PRODUCT CHANGE NOTIFICATION

PCN No.: PCN-202610-014	**PCN Doc No.:** EC-20261029-PCN-03	**Date Issued:**	10/29/2026
Part Number or Series: MTJ-88SX1-FS-SMT-PG-L51-M532Y-WOT		**PCN Effective Date:**	10/29/2026
Customer: (If applicable)		**P/O No.: (If applicable)**	Not affected
Type of Change: ■ Process Change		**Last Time Buy Date:**	Not affected
Traceability Marking/Date code: No change		**Last Time Ship Date:**	Not affected
Replacement Part Number:		**Sample Availability Date:**	Not affected

Before Change	After Change

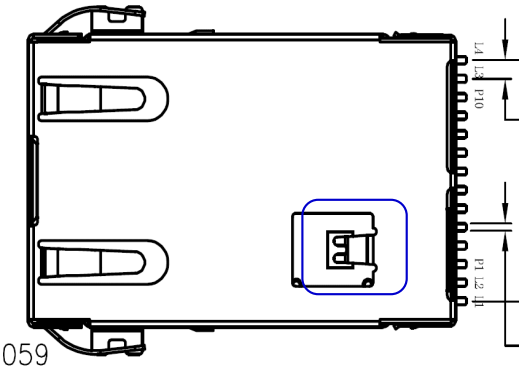
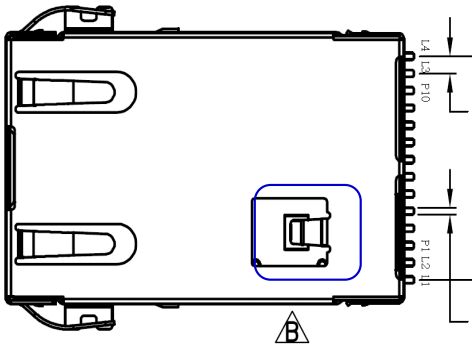
Change Description: The welding process for grounding iron shells has been changed from soldering machine welding to laser welding,The material of the shell material has been changed from "Copper Alloy" to "Stainless Steel";

.059 Material: Housing: Hi-Temp Thermoplastic, rated UL 94V-0, Color: Black Insert: Hi-Temp Thermoplastic, rated UL 94V-0, Color: Black Contacts: Phosphor Bronze Solder Tail Terminal: Brass, Matte Tin plated Shield: Copper Alloy, Nickel plated	Material: Housing: Hi-Temp Thermoplastic, rated UL 94V-0, Color: Black Insert: Hi-Temp Thermoplastic, rated UL 94V-0, Color: Black Contacts: Phosphor Bronze Solder Tail Terminal: Brass, Matte Tin plated Shield: Stainless Steel, Nickel plated A
Before the change: 1、Appearance ~ As shown in the above picture; 2、Material Shield: Copper Alloy, Nickel plated	After the change: 1、Appearance ~ As shown in the above picture; 2、Material Shield: Stainless Steel, Nickel plated
